**Part 1            ADDENDUM NO.1**

FALCON LAKE HOUSE  
FALCON LAKE, MB  
CAN-TEC SERVICES LTD  
06 SEPTEMBER 2017

PROJECT TITLE: RCMP-FALCON LAKE HOUSE  
 SHEET TITLE: KITCHEN ELEVATION / SECTION  
 DATE: 17-07-11  
 SCALE: AS NOTED  
 LOCATION: 17 FALCON BV, FALCON LAKE, MB  
 CHECKED BY: RS  
 DRAWN BY: RQS

**A5.2**

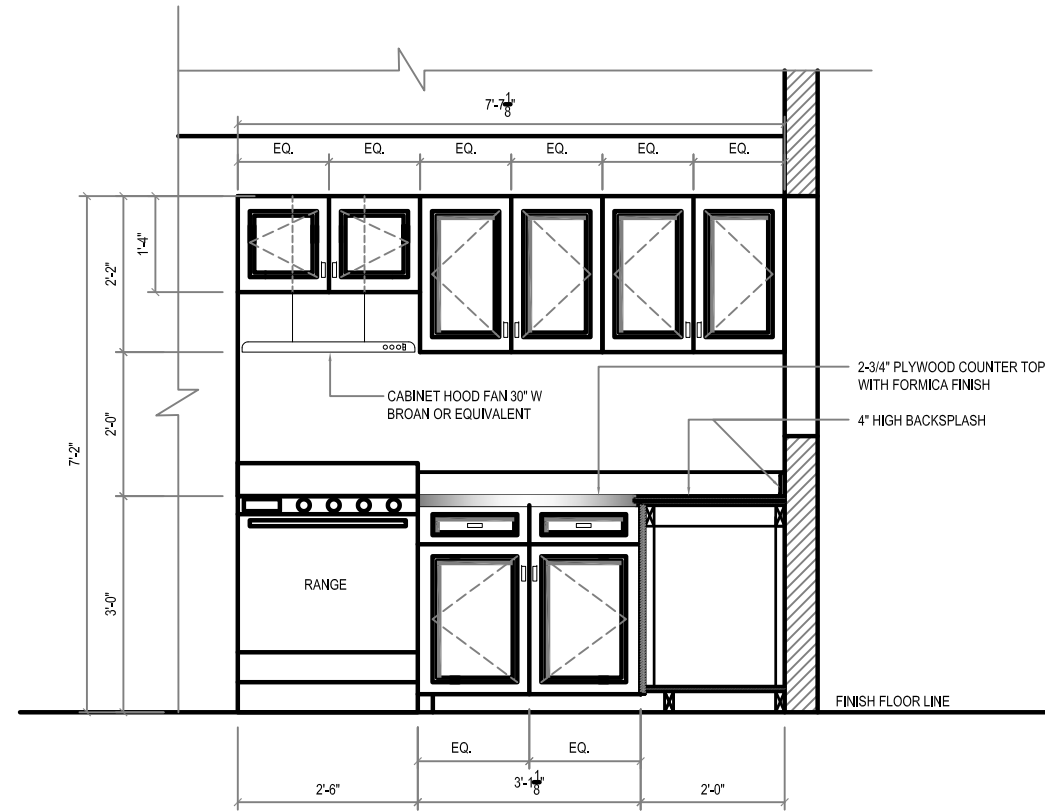
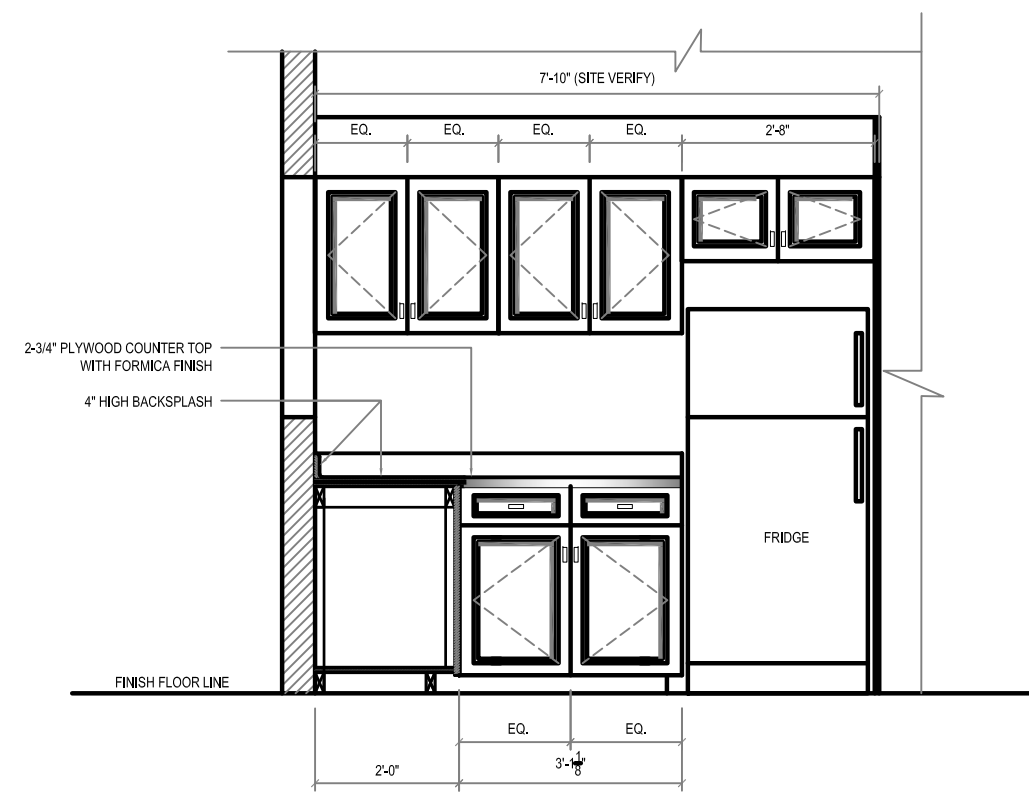
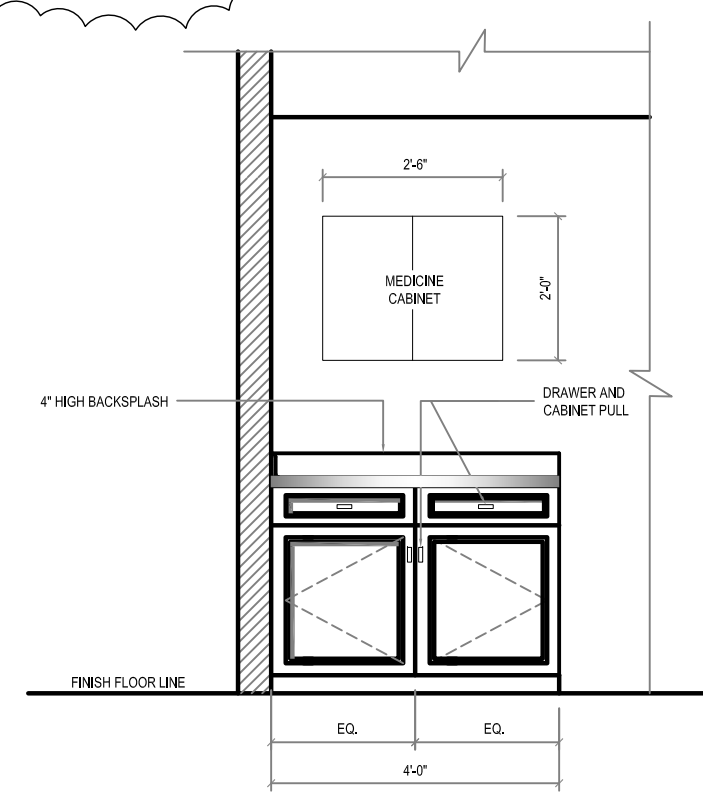
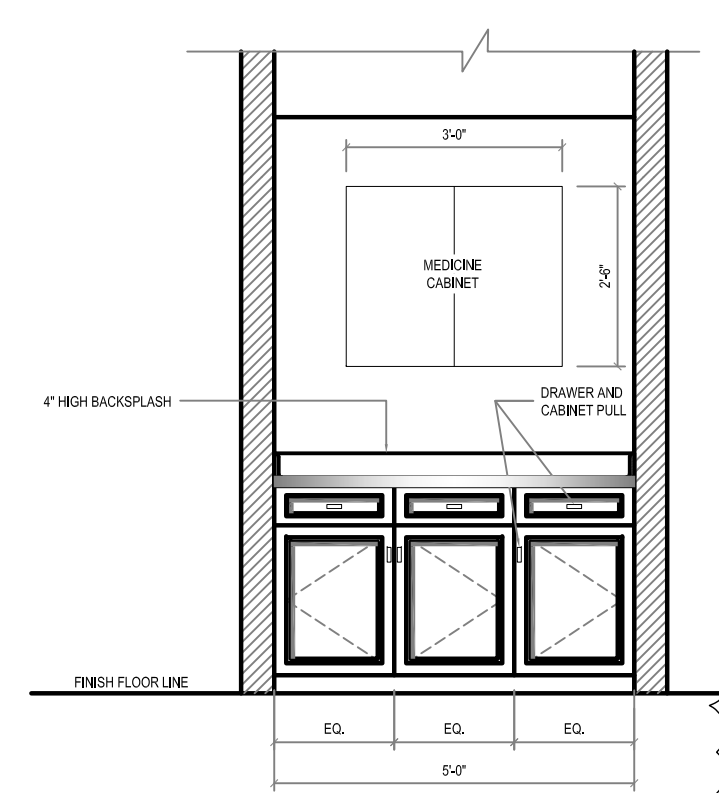
See attached Sketch for Bathroom Vanities Drawing A5.2 Rev 02

- .1 Add double cabinet above fridge see attached modified detail. Sheet A5.2 Rev 02

**M1.1**

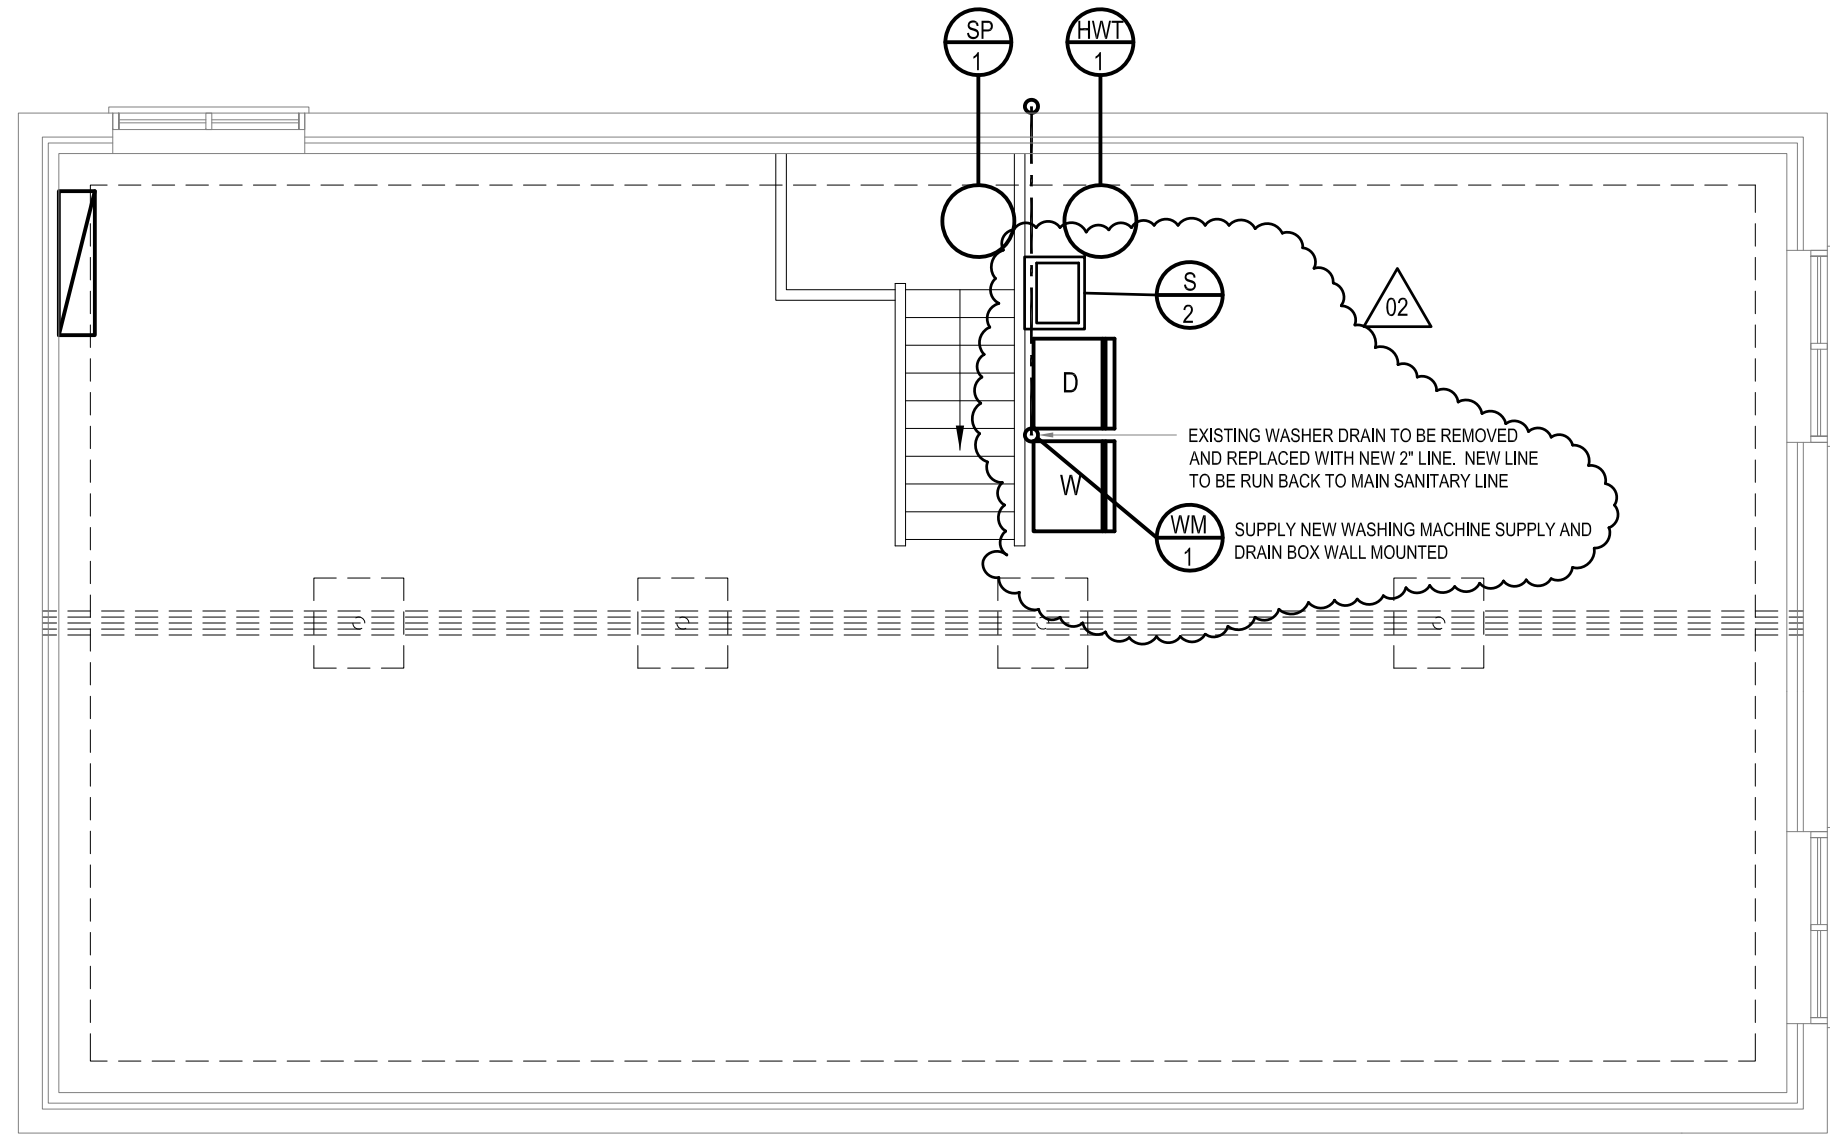
- .1 Add new laundry tub next to washer and dryer. See specification for type. See Drawing M1.1 Rev 02

- .1 Existing washer drain is under sized currently at 1 ½" diameter. Remove existing 1 ½" drain line to main drain and install new 2" dia drain line. Note: removal of the line will involve demolition of concrete floor to main sanitary line. See drawing M1.1 Rev 02
